SECOND GENERATION DISTRICT PLAN

Variation 2 – Additional Housing Capacity Part 3 – Sites Proposed for Rezoning

Appendix D.2

Evidence on Hazards

Figure 1 – RS220: 53, 64, 73, 74, 80, 85, 86, 92, 100, 103, 103A, 123, 127 SCROGGS HILL ROAD

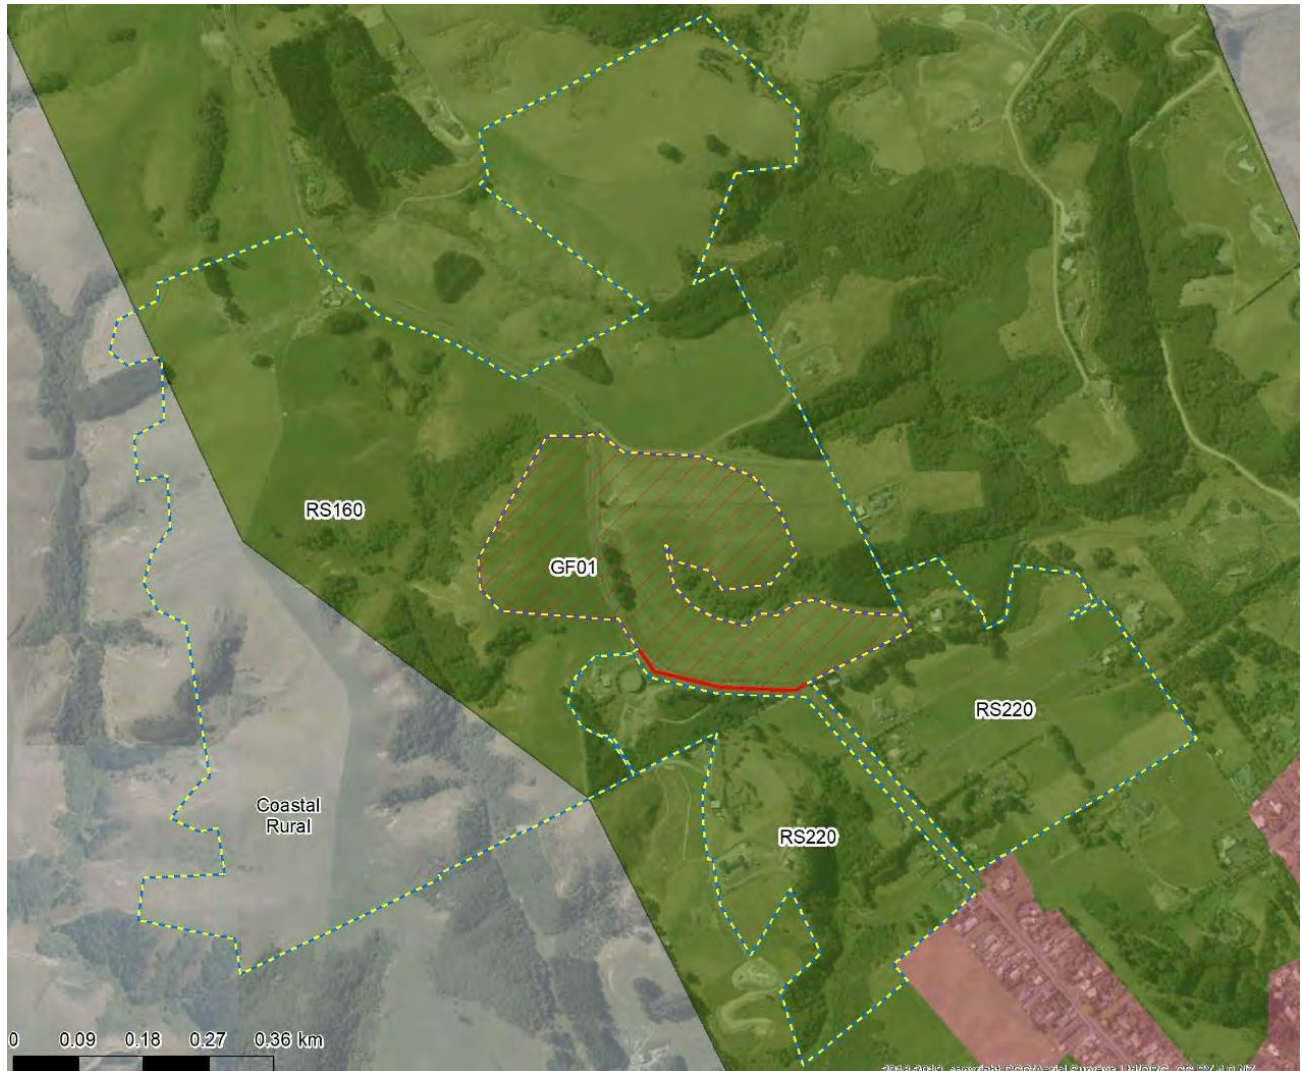
We consider that this site is a **medium level hazard**. This decision is based on the following summary of information:

- There are **medium level hazards** associated with slope instability on the site
 - o Global stability of steeper parts of the site appears to be governed by stormwater management and steepness/aspect of the slopes.
 - o Geotechnical advice will be required prior to subdivision of this site to confirm the extents of instability and ensure it will not affect any potential lots/structures. This may also identify any offsets that might be required from unstable areas.

Geotechnical assessment will be required to confirm the stability of proposed lots near steep portions of the site. Provided the site is found to be globally stable, some specific earthworks and stormwater management requirements would be applicable for lots on the site. It is likely that removal of trees from the gully areas will exacerbate instability.

Figure 5 – RS204: 21, 43, 55, 65, 75, 79, AND 111 CHAIN HILLS ROAD

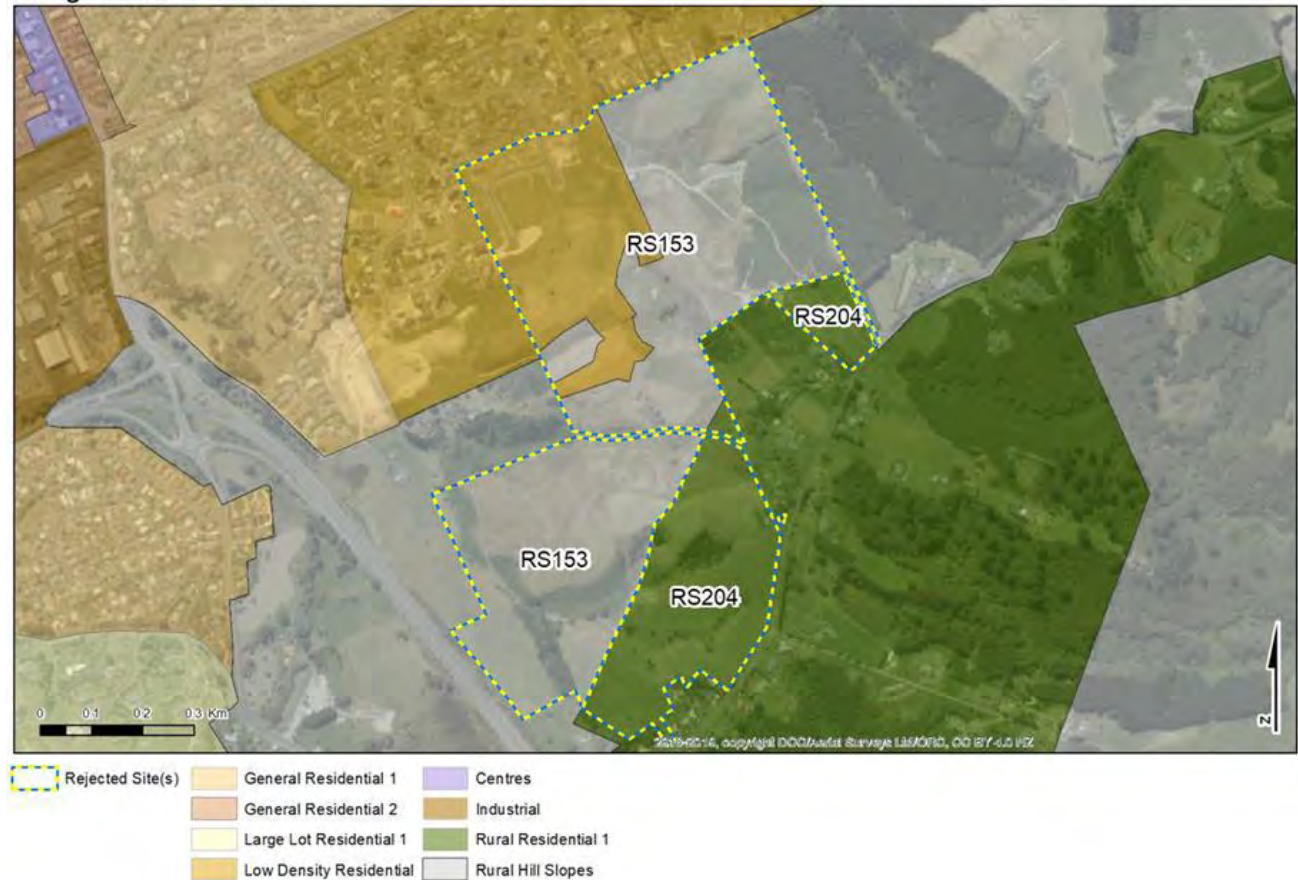
We consider that this site is a **low to medium level hazard**. This decision is based on the following summary of information:

- There are **low level hazards** associated with slope instability on the site in slopes less than 12 degrees adjacent to Chain Hills Road:
 - o Much of the site itself is within typical stability limits.

- o Geotechnical advice will be required prior to subdivision of this site to confirm the extents of instability in the adjacent steeper slopes and ensure it will not affect any development. This may also identify any offsets that might be required from any gully features.

- There are **medium level hazards** associated with slope instability within gully features:
 - o Stability of steeper parts of the area appears to be uncertain (on slopes greater than 15 degrees). In some areas, the site is steep and with prehistoric landslide features that require geotechnical assessment.

- o Geotechnical advice will be required prior to subdivision of this site to confirm the extents of any instabilities and ensure they will not affect any adjacent lot. This may also identify any offsets that might be required from unstable slopes

Geotechnical assessment will be required to confirm the stability of the gullies across the site. Provided the site is found to be globally stable, requirements for earthworks consent would be normal for low angled lots (<15 degrees) within this area.

Figure 6 – RS153: 77 and 121 Chain Hills Road and 100 Irwin Logan Drive

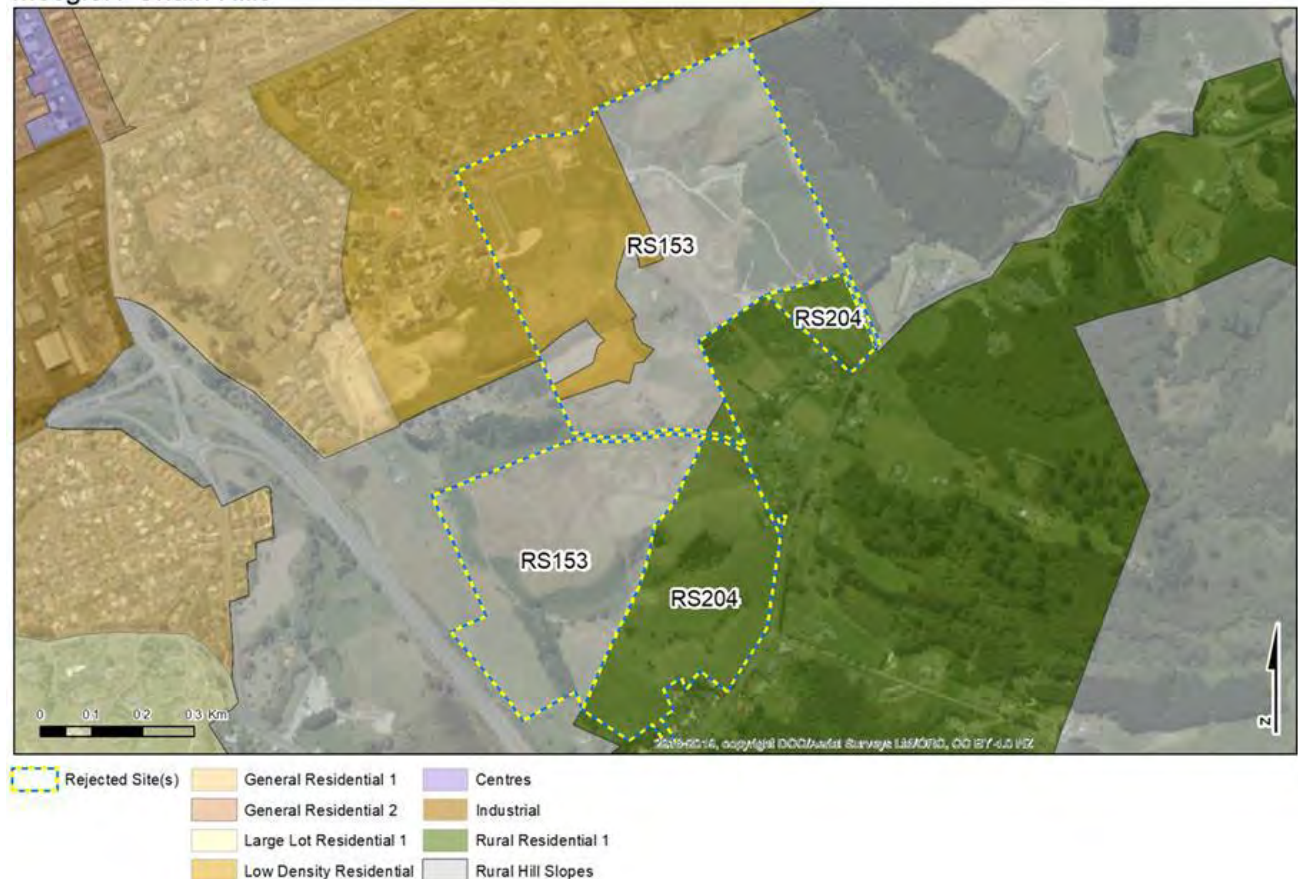
We consider that this site is a **medium level hazard**. This decision is based on the following summary of information:

- There are **medium level hazards** associated with slope instability:
 - o Most of the site consists of undulating terrain with steep slopes over 15 degrees. In some areas, the site is steep and with prehistoric landslide features that require geotechnical assessment.
 - o Geotechnical advice will be required prior to subdivision of this site to confirm the extents of any instabilities and ensure the proposed subdivision layout will not limit the ability to address these hazards. This may also identify any offsets that might be required from unstable slopes

Geotechnical assessment will be required to confirm the stability of the gullies across the site. Provided the site is found to be globally stable, requirements for earthworks consent would be normal for low angled lots (<15 degrees) within this area.

We do not anticipate that this site will be generally unstable, though much of it will be unsuitable for structures. Geotechnical advice will need to identify building platforms and lot layouts/sizes that will work with the terrain features and not confuse the ability to address these hazards.

Figure 7 – RS161: PART 210 SIGNAL HILL ROAD

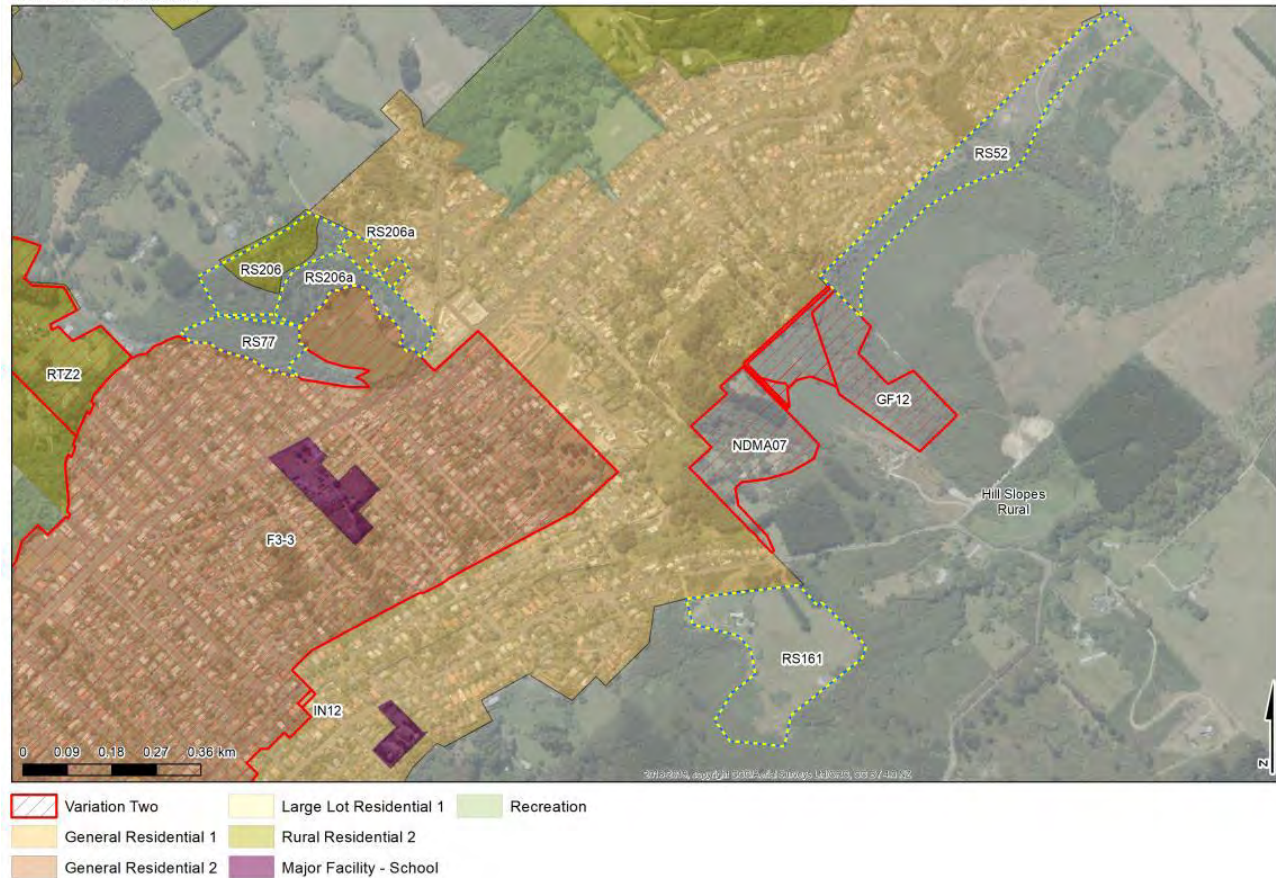
We consider that this site is a **low hazard level**. This decision is based on the following summary of information:

- There are **low hazards** associated with slope instability within the proposed area. The area appears to have been explicitly chosen to avoid the steeper slopes surrounding the site.

There is readily developable land within the proposed area, however geotechnical investigation and assessments of the adjacent slopes may be pertinent to confirm the extents of the readily developable land.
